Planning Commission Staff Report

Subject:Treasure HillAuthor:Katie CattanPL/Date:January 7, 2009Type of Item:Administrative – Conditional Use Permit

Exhibit A: Original Master Plan Development Exhibit for Height

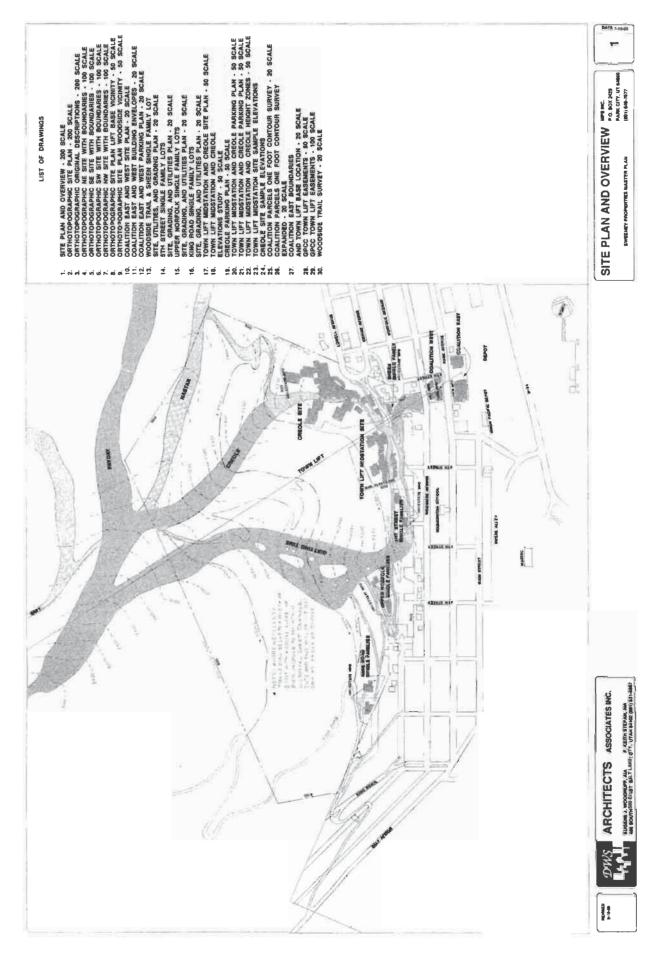
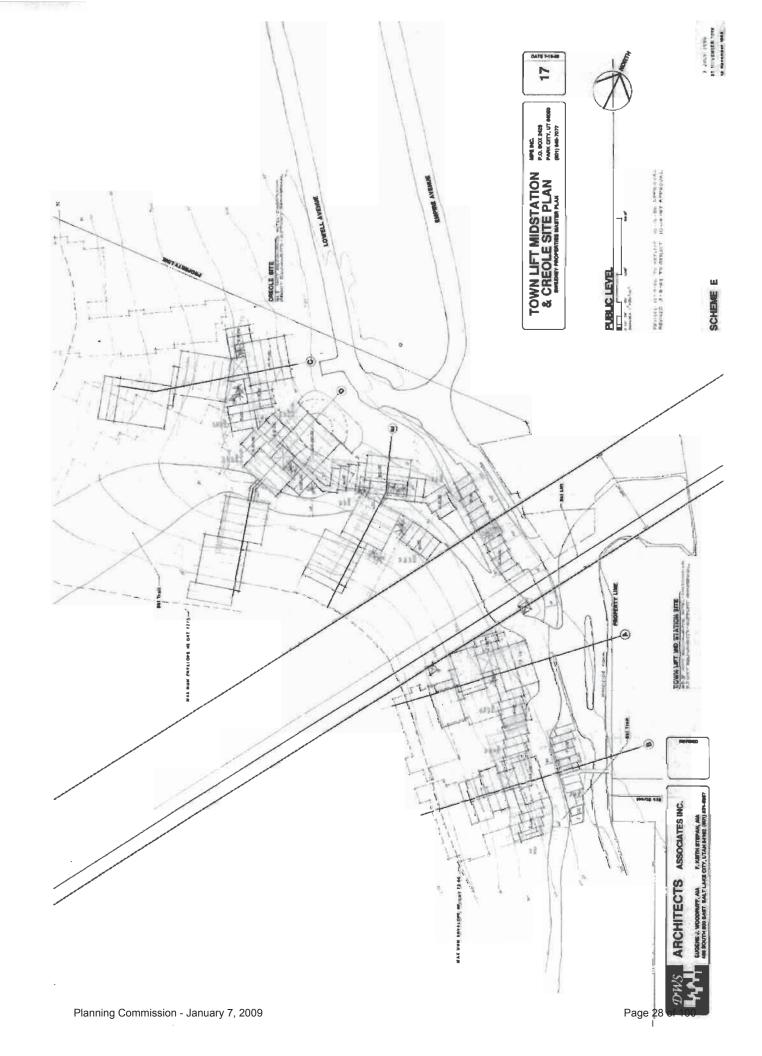
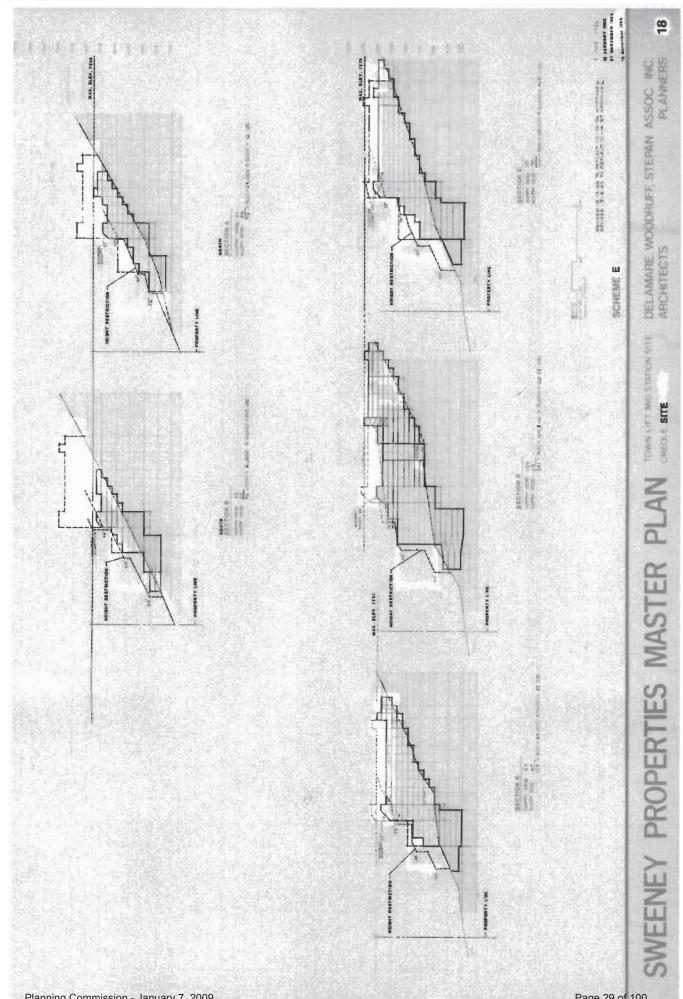
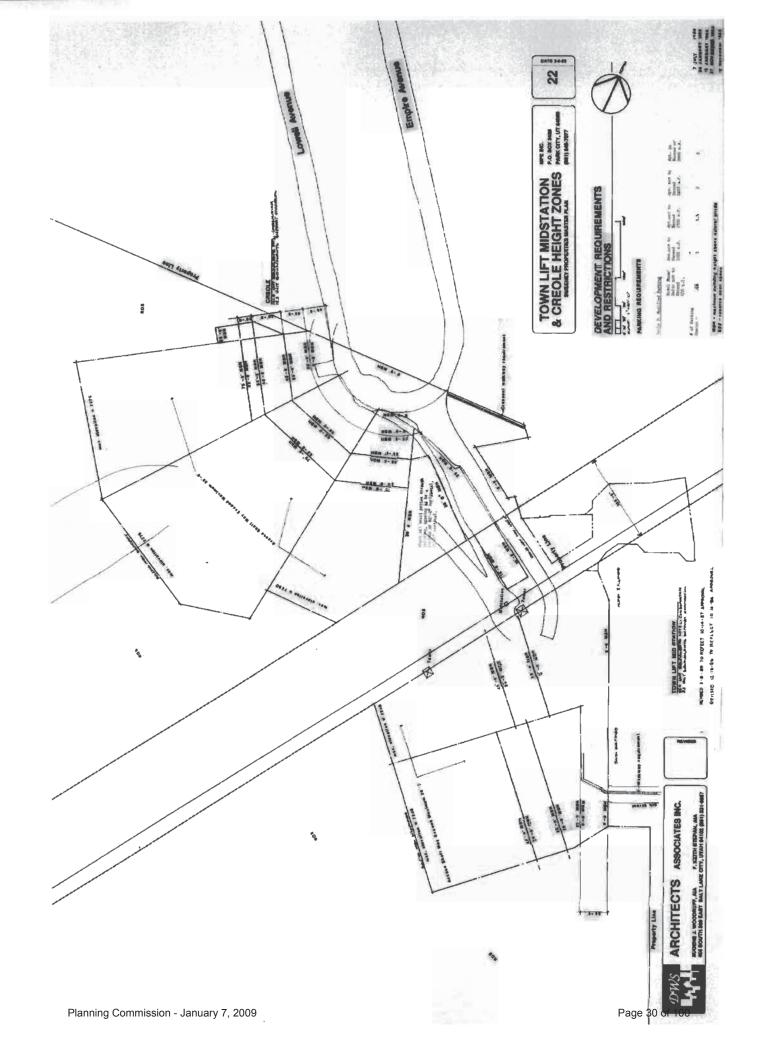
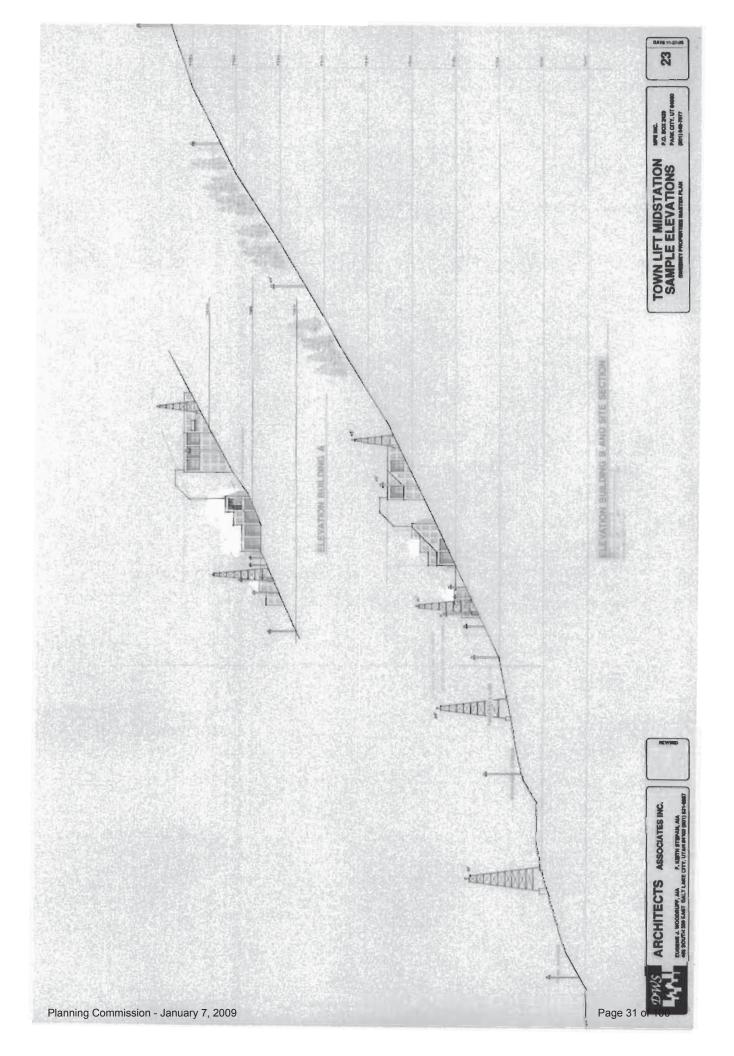
a. What the Sweeney Properties 1985 MPD Exhibits Illustrate: The above-cited statement is not clearly consistent with the exhibits associated with the 1985 Master Planned Development approval. Several discrepancies have been noted by Staff. The setbacks for above-ground structures vary to some degree from one MPD exhibit to another. <u>The Sweeney Properties 200 Scale Site Plan, Sheet No. 2</u> (dated May 5, 1985—See Exhibit A) shows approximately an 80 ft. to 100 ft. setback from the back of pavement of the Lowell/Empire Avenue switchback to the closest "above-ground" building footprint. <u>The Sweeney Properties 50 Scale Site Plan & Grading Sheet No. 8</u>

(dated May 10, 1985—See Exhibit F) indicates approximately a 90 ft. setback from the back of pavement of the Lowell/Empire Avenue switchback to the closest building footprint. <u>The Town Lift Midstation & Creole Site Plan, Sheet 17, Scheme E</u> (dated November 13, 1985 and updated on November 27, 1985 and July 7, 1986—See Exhibit A) indicates a minimum building setback of approximately 75 feet.

The MPD exhibits illustrating the underground parking plans indicate setbacks ranging roughly from 20 to 25 feet (<u>Creole Parking Plan Sheet 19</u>, dated June 10, 1989—See Exhibit A.) <u>The Town Lift Midstation & Creole Height Zones Sheet 22—Development</u> <u>Requirements and Restrictions</u> (dated July 7, 1986—See Exhibit I) identify maximum building heights and show a 0 ft. maximum building height approximately 40 ft. back from the Lowell/Empire Avenue switchback.

c. Planning Department Analysis of the Setback Issue: The current Treasure Hill conditional use permit site plan is not consistent with the 1985 staff report narrative that states "*substantial 100'+ setbacks from the road*" are provided. The staff report statement is unclear whether it refers to "above-ground" or "below-ground structures". Even if the author intended the statement to mean above-ground buildings and not Land Management Code defined "Structures" which include parking garages and retaining walls, the small staircase building on the plaza (with a 40 ft. setback) and Buildings 3b and 4a (with setbacks ranging from approximately 75-80 ft.) do not meet the "substantial 100 ft. setback from the road" description.

Rather than debate staff report narrative versus MPD exhibits, the Planning Department suggests time be spent achieving a design which best meets the original MPD design intent. Staff believes that the original intent of the 1985 MPD was to establish a sizeable setback, landscape buffer, transition area between the edge of the street/neighboring residences and the proposed vertical construction. Staff defines "vertical construction" to mean buildings, retaining walls, rock walls, parking garage entrances, etc. It is the nature, scale, and design, as well as the pedestrian character of these vertical features within this interface area which will be critical in determining "neighborhood compatibility."

Staff would like the Planning Commission to determine whether or not they agree with staff's analysis that the original Master Plan Development was unclear regarding setbacks. Does the Planning Commission agree that setbacks were to comply with the 1985 MPD exhibits showing maximum building heights and that no above ground buildings may exist within the 0' Maximum Building Height area as shown on the Master Plan Development Exhibits (Exhibit B). All above ground improvements (retaining walls and stairs) within the 0' MBH area must comply with the exceptions allowed for the front, side, or rear yard under the LMC.
